EQUIPMENT TYPE KWM-1

BULLETIN NO. 1

9-12-58

SUBJECT A: Improvement in Calibrator Operation**B: Spurious Outputs of KWM-1****C: Transient in Speaker when Switching from Receiver to Transmit****D: Hum in Speaker when AF Gain Control is Advanced in CW Operation****E: "Tweets" in Audio Output Caused by DC Power Supply**

Figure 1. Wiring Location of L1 Shield Can

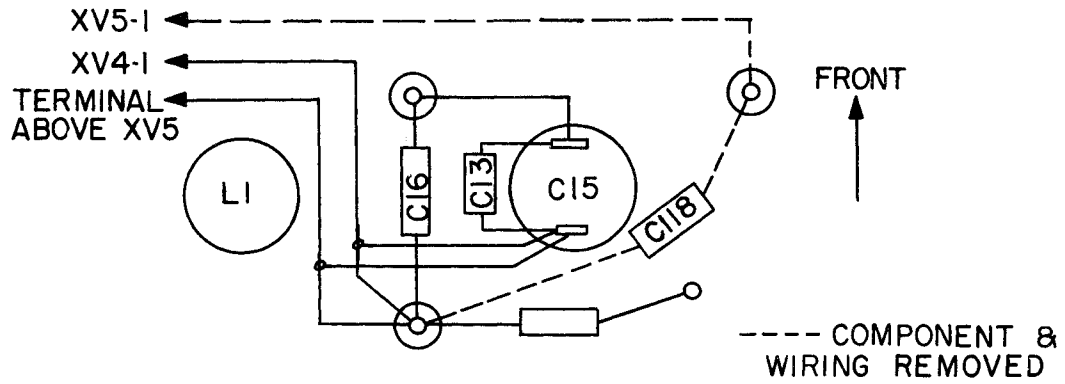
4. Remove 1 uuf capacitor, C118, and coax lead from C118 to XV1 pin 5. C118 and coax

lead are connected to insulated terminal mounted on trimmer capacitor. Discard coax and capacitor. See figure 1.

7. Install a five inch length of coax cable (425 0926 00) from terminal directly over XV5 pin 9 (installed in step 5) to insulated terminal to which C16 and coax cable to XV4 pin 1 is connected. See figure 1. Ground coax shield to C15 as shown in figure 1. Ground shield at C15 end only.

Figure 2. Location of Number 29 Hole for Installation of Insulated Terminal

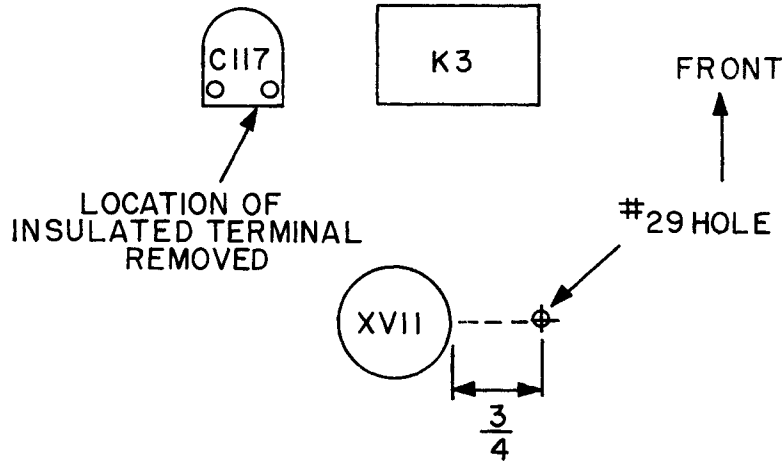
13. Unsolder .001 capacitor and coax from the insulated terminal mounted on "Cal Zero"

capacitor, C117, (insulated terminal on K3 side of capacitor) and remove insulated terminal from capacitor. See figure 2.

15. Drill new hole as indicated in figure 2. Care should be taken not to damage wiring and other components when drilling this hole.

Figure 3. Partial Schematic V1, After Modification

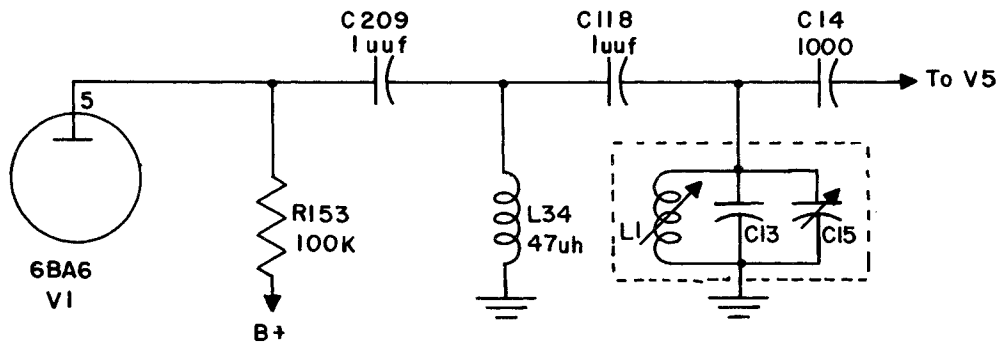
19. Check circuit for correct wiring as shown in Figure 3.

Figure 4. Location of Number 29 Hole for Installation of Insulated Terminal

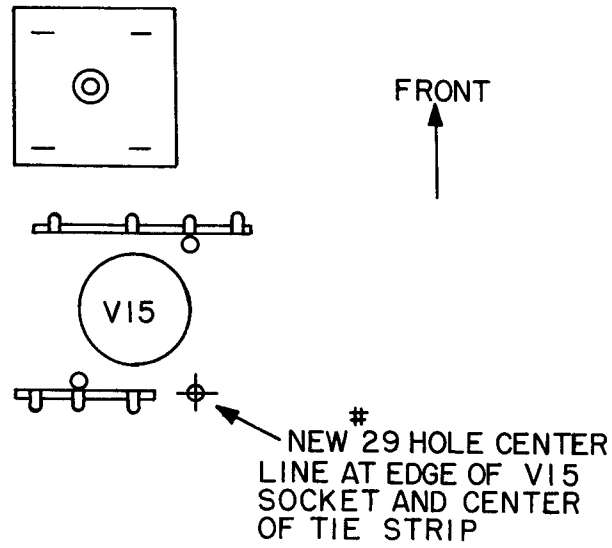
1. Remove the 330K 1/2 watt resistor, R124, connected to terminal on terminal strip behind XV12. (See Figure 6). R124 should be removed by cutting from the strip and discarded.
2. Carefully drill a number 29 hole next to tie strip at rear of XV15 as shown in figure 4. Care should be taken not to damage cable harness.
3. Mount insulated terminal (306 0233 00) in hole drilled in step 2 using 4-40 x 3/16 screw (343 0284 00).
4. Connect a new 330K resistor, R124, (745 1457 00) from center terminal of terminal strip behind XV12 to insulated terminal installed in step 3.
5. Connect 330K resistor, R156, (745 1457 00) from insulated terminal installed in step 3 to

Figure 5. Partial Schematic V15, After Modulation

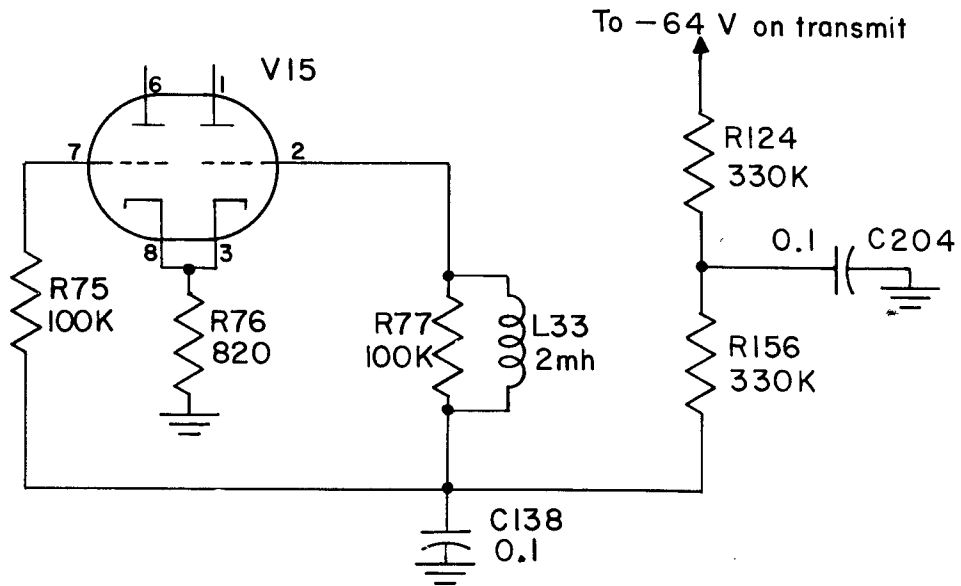
6. Connect .1 uf capacitor, C204, (931 0299 00) from insulated terminal installed in step 3 to same ground as C138. See figure 6.
7. Check XV15 pin 2 for the presence of a 2.2 mh rf choke connected across the 100K resistor connected to this pin.
8. If the choke is not present, connect a 2.2 mf choke (240 0084 00) across the 100K resistor, R77, connected to pin 2 of XV15.
9. Refer to figure 5 for schematic of completed modification.

Figure 6. Location of Components, Bottom View

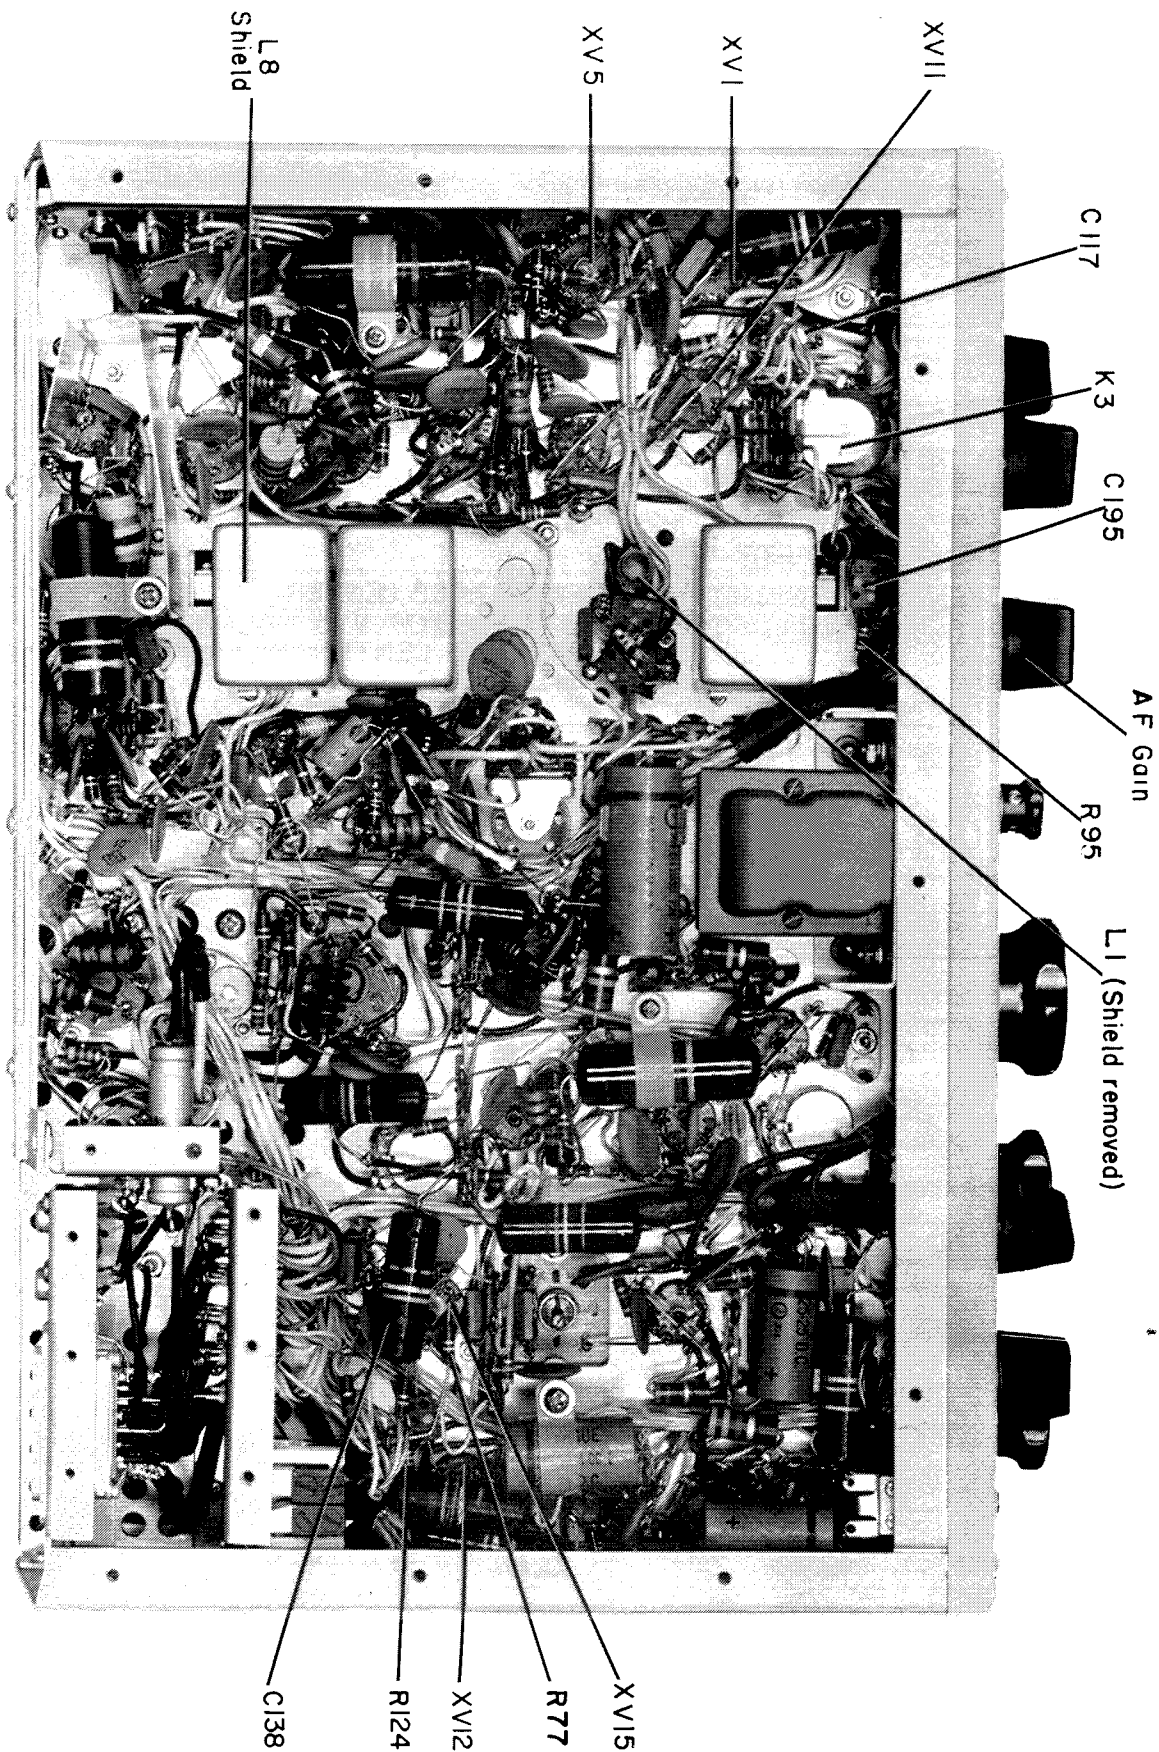
3. Remove L1 coil can. (L1 can is located beside XV4 and is second can nearest front of the unit). See figure 6.

1. Remove the L8 shield can. See figure 6.
2. Install five ground clips (220 1323 00) around edge of the can and replace in original location. Make sure that can mounting nuts are tight.

In earlier models of the KWM-1, some hum could be heard if the AF Gain control was run high when in CW operation. This is actually a low frequency oscillation in the sidetone circuit and may be eliminated by the following modification. Units that have this modification installed will have a four terminal tie strip mounted directly behind the RF and AF gain controls with a 470 K 1/2 watt resistor connected in series with a 220 uuf capacitor mounted on the strip. Figure 6 shows the modified circuit.
